This Service Letter is reidentified as
Service Bulletin **EM 20-97**
per Service Instruction M20-15.

SUBJECT: Installation of 310141 Sealing Strip Assembly Windshield Cowling

MODELS AFFECTED: M20A, M20B, M20C, Serial Numbers 1201 thru 2296

FIGURE 2

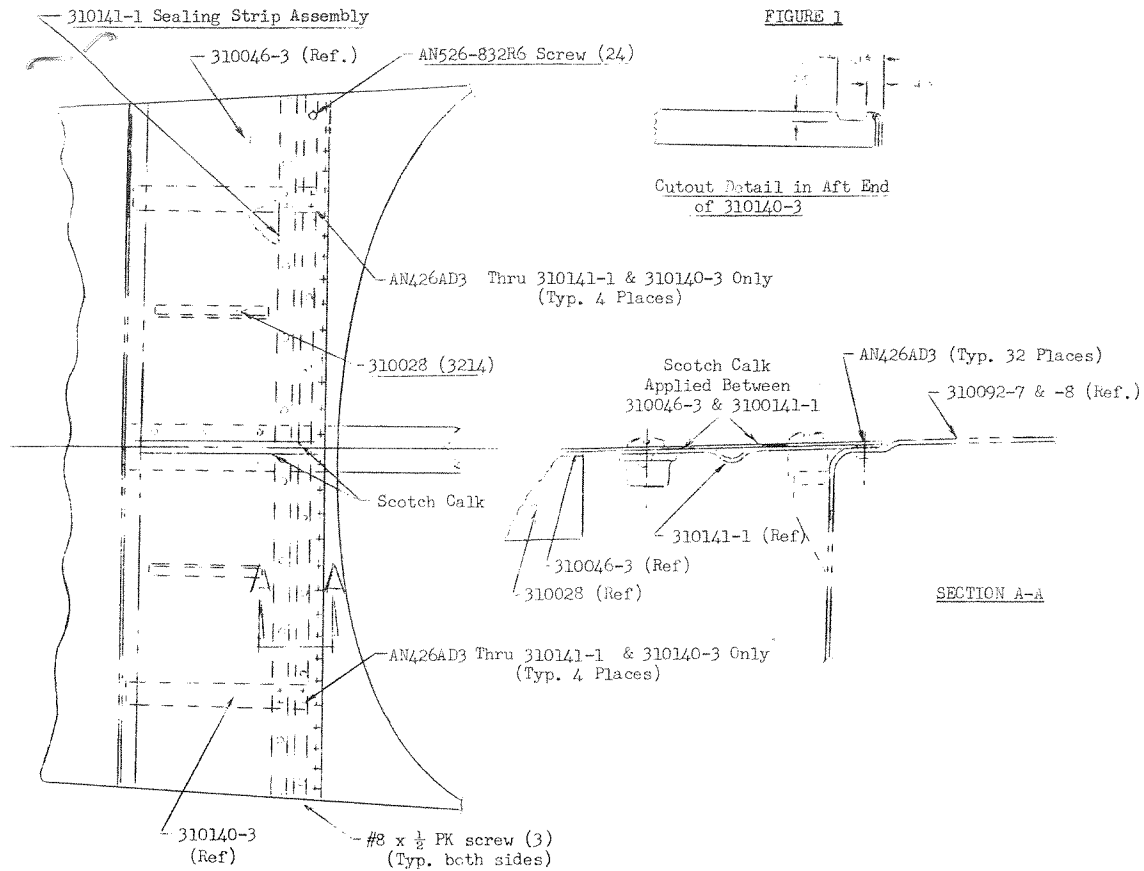
1. Remove 310046-3 (3251) access panels.
2. Remove 310045 (3250-1 & -2) windshield outer flange.
3. Remove 310047 (3252) windshield center strip.
4. In aft end of 310140 (3524), add a cutout .69" wide by .25" deep, to start .45" from aft end of 310140 (3524).

5. Cut .75" from aft end of 310028 stiffener, located on the under side of 310046-3 (3251) access panel, to clear the drain bead in 310141-1 sealing strip.

6. Align the holes in 310141 and 310046 (3251) and back drill the forward holes in 310046 (3251) to match 310141.
7. Secure 310141 to 310092 (3379) with the original hardware. Drill 310092 (3379) to match 310141 and countersink for AN426AD3 rivet (32 places). Remove 310141 and apply a brush coat of PR1321-B2 sealer to the forward edge of 310029 (3379) cowling and on the rear under side of 310141. Install AN426AD3 rivets (32 places).

8. Drill 310140 (3524) to match 310141 (typ. 2 places) and install AN426AD3 rivets.
9. Remove hardware used to secure 310141 to 310092 (3379) while drilling and riveting.

10. Re-install 310046 (3251) access panels.
11. Drill .250 diameter hole 1.50 up from lower end of 310046-3 (3251) (typ. both sides). Hole to be centered over bead in 310141-1.
